PREVOST

WARRANTY BULLETIN

WB15-08

.DATE :	FEBRUARY 2015	SECTION :	18 - Body
EXPIRATION:	FEBRUARY 2017		
SUBJECT :	DRIVER'S SEAT BASE

Figure 1

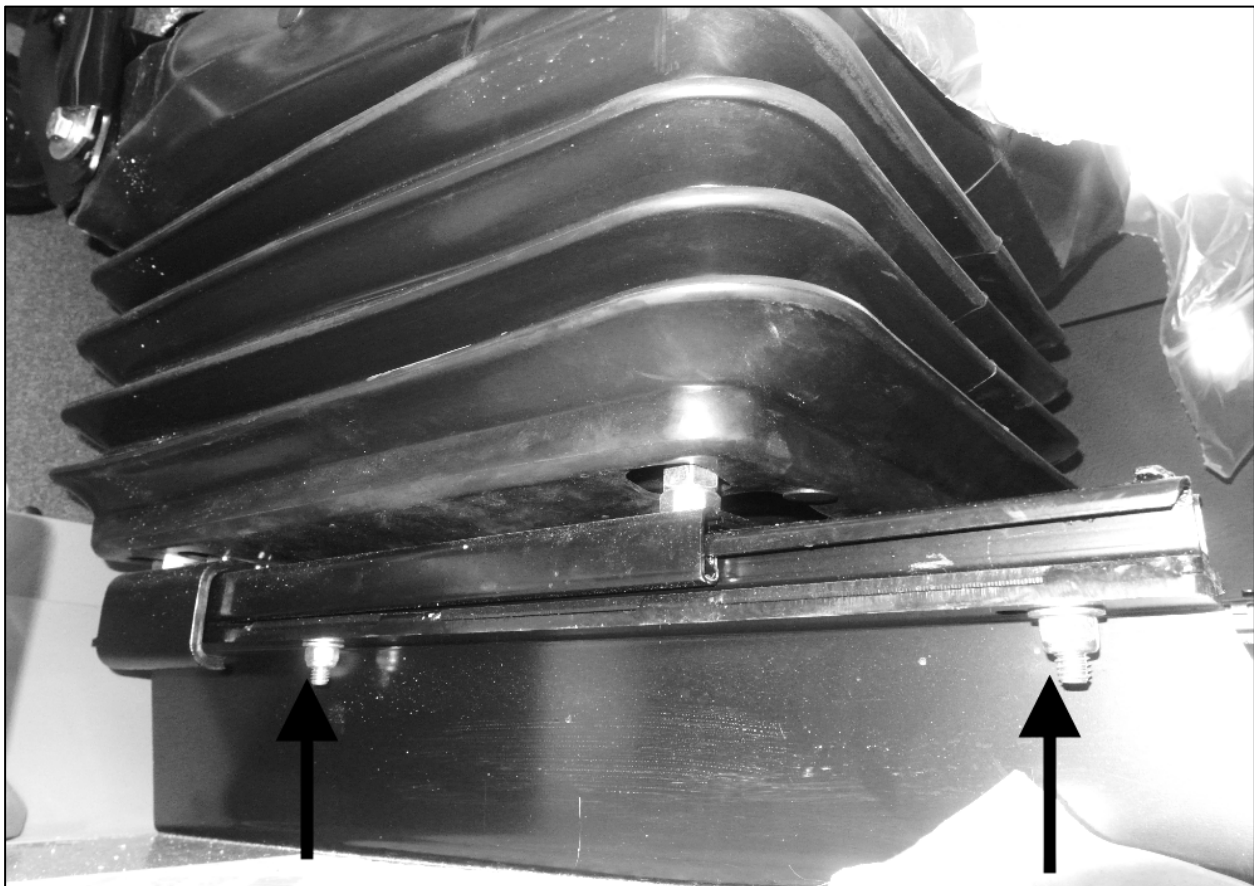
On each side of the seat base, make sure the four (4) nuts are tightened. (Fig. 1)

Tighten to 11 lbf-ft
